# Access Compliance Report

## Public Rights-of-Way

### (Curb Ramps)

Intersection ID: 10030	Main Street: E_28TH_ST	Cross Street: N_TRYON_ST	Location: SE
ADA ID: C177E675ED1F	Ramp Type: PerpDiag	Initial Pass/Fail: Fail	Overall Compliance: No
Severity Score: 48.75			
Codes/Mitigation Info/Possible Solution		Field Measurements/Component Compliance

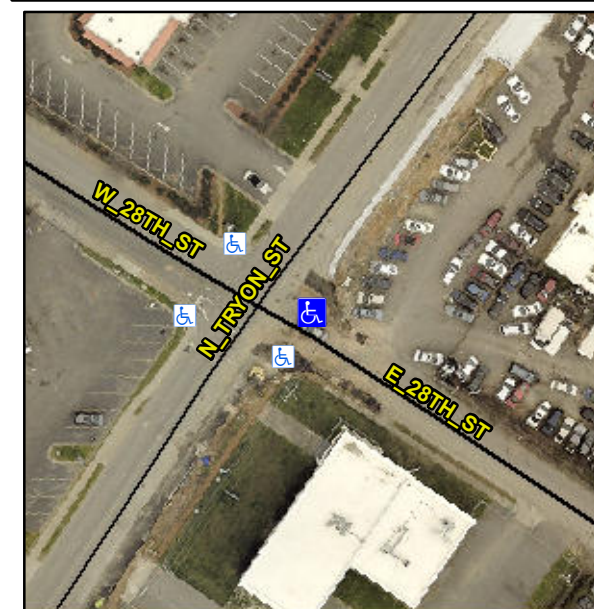
**Not Found, R304.5.1, R304.5.3, R302.7**

Compliance	Description	Data	Compliance	Description	Data
N/A	Ramp Length (in)	59.5	Yes	Ramp Slope (%)	6.0
No	Ramp Width (in)	36.0	No	Ramp XSlope (%)	7.8
N/A	Flare Type LT	N/A	N/A	Flare Type RT	N/A
N/A	Flare Slope LT (%)	N/A	N/A	Flare Slope RT (%)	N/A
N/A	Flare Traversable LT?	N/A	N/A	Flare Traversable RT?	N/A
N/A	Landing Length (in)	N/A	N/A	DWS Provided?	N/A
N/A	Landing Width (in)	N/A	N/A	DWS Contrast?	N/A
N/A	Landing Slope (%)	N/A	N/A	DWS Length (in)	N/A
N/A	Landing X Slope (%)	N/A	N/A	DWS Full Width?	N/A
N/A	Landing Curb? (Y/N)	N/A	N/A	DWS Offset (in)	N/A
N/A	Shared Landing?	N/A			
N/A	Gutter Ponding?	N/A	N/A	Gutter Slope (%)	N/A
N/A	Gutter Lip Ht (in)	3.0	N/A	Gutter X Slope (%)	N/A
N/A	Painted X Walk1?	Yes	N/A	Painted X Walk2?	No
	X Walk 1 Direction	To NW		X Walk 2 Direction	To SW
N/A	X Walk 1 Width (in)	122.0	N/A	X Walk 2 Width (in)	N/A
	X Walk 1 Slope (%)	1.9		X Walk 2 Slope (%)	5.2
	X Walk 1 X Slope (%)	4.9		X Walk 2 X Slope (%)	1.0

N/A	Ramp inside XWalk1?	Yes	N/A	Ramp inside XWalk2?	N/A
	Road Slope (%)	3.7	N/A	Clear Space?	N/A
	Road X Slope (%)	3.7	N/A	Clear Space to XWalk (in)	N/A
N/A	Any Obstructions?	N/A	N/A	Storm Grate/Utility Hazard?	N/A
	Obstruction Type			Storm Grate/Utility Type	
		N/A			N/A
		No		Surface Condition? (G/P)	Poor

**Remove & Replace Curb Ramp With Two New Directional Ramps or Equivalent.**
